Haddam Neck Plant
Response to Request for Additional Information, VIPRE/WRB-1
DNBR Thermal Limit for Westinghouse Fuel Types

Haddam Neck Plant

Response to Request for Additional
Information, VIPRE/WRB-1 DNBR Thermal
Limit for Westinghouse Fuel Types

Schematic of VIPRE Model used for 5x5 Test Configurations

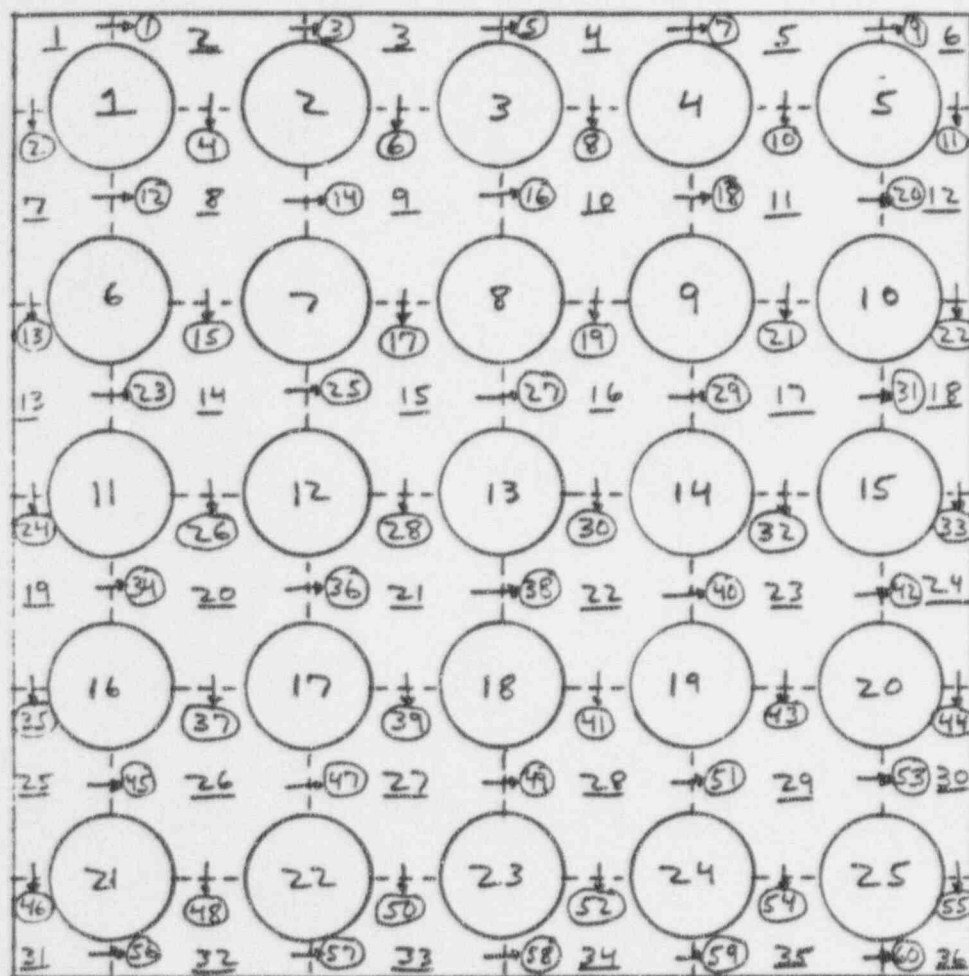
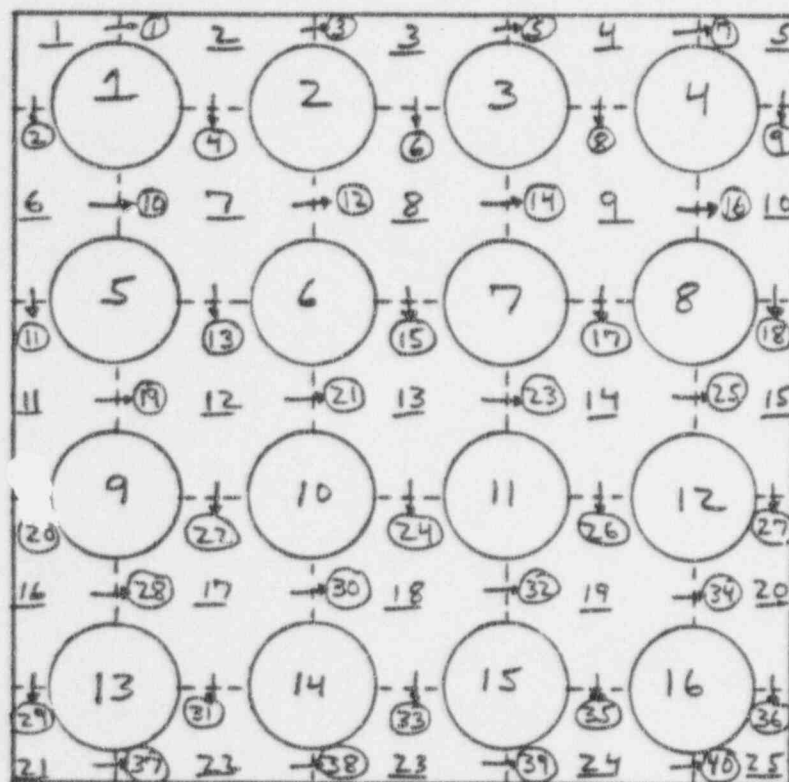
Tables A-1 through A-22 of the report list the hot channel and the hot rod in the bundle. Are they 'measured' or 'predicted'? Please provide the numbering scheme and radial layout of the VIPRE simulation. Do the 'predicted' channels and rods match those of the measured data?

The hot channels and hot rods shown in Tables A-1 through A-22 of the NUSCo Topical Report are those which were predicted by the VIPRE code to experience minimum DNBR.

The rod and channel numbering schemes used in the NUSCo VIPRE analysis are attached.

The measured test data indicating which channel and rod experiences DNB is not readily available. Therefore, comparisons between 'measured' and 'predicted' rods cannot be made. Even if the measured data were easily accessible, only the rods which first reach DNB could be compared, since DNB was based upon thermocouple data from the rods and not the channels. In addition, because of the symmetry involved and the randomness in the rods which first experience DNB, this type of comparison is not likely to be very meaningful.
